Production Discontinuation of Relay Terminal Modules and Their Dedicated Connection Cables

June 2023 (Ver. B: February 2026)

A6TE2-16SRN, AC06TE, AC10TE, AC30TE, AC50TE, AC100TE

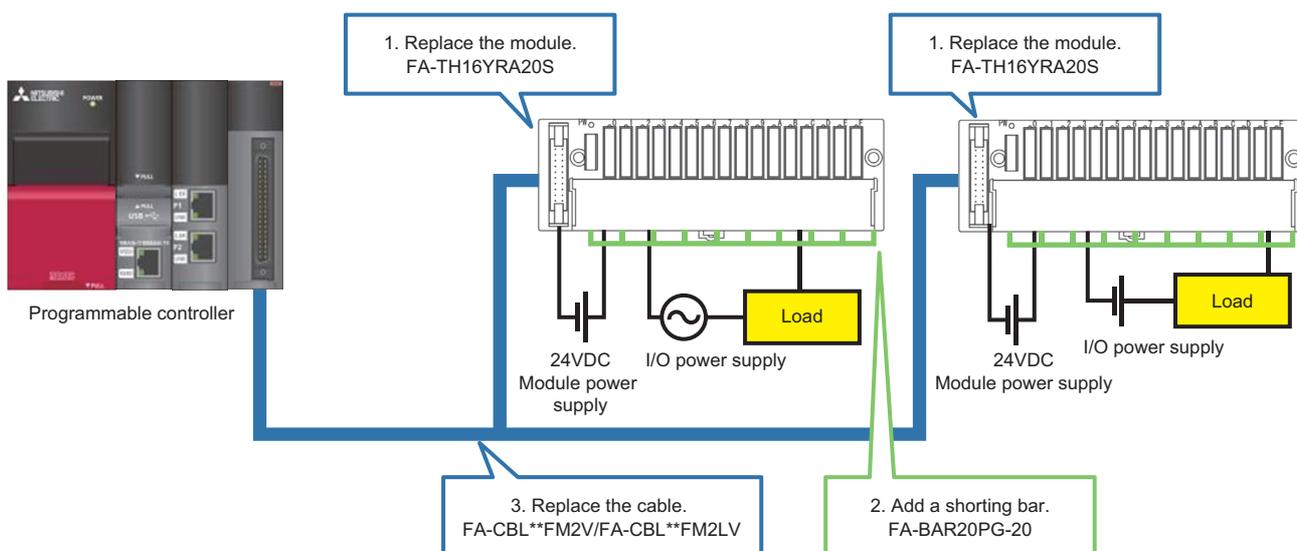
*1 Because the wiring method for common is different, a shorting bar is required. (Page 3 REPLACEMENT PROCEDURE)

*2 The rated switching voltage is changed from 240VAC to 200VAC, however, there is no problem in using the current I/O power supply because the maximum switching voltage is 270V.

1. Replace the A6TE2-16SRN with the FA-TH16YRA20S.
2. Add the shorting bar FA-BAR20PG-20 to the FA-TH16YRA20S.
3. Replace the connection cable AC**TE with the FA-CBL**FM2V or FA-CBL**FM2LV. The available output module differs depending on the shape of connector on the programmable controller side. To select a connection cable, refer to Page 3 SELECTION OF DEDICATED CONNECTION CABLE FOR TERMINAL MODULES.
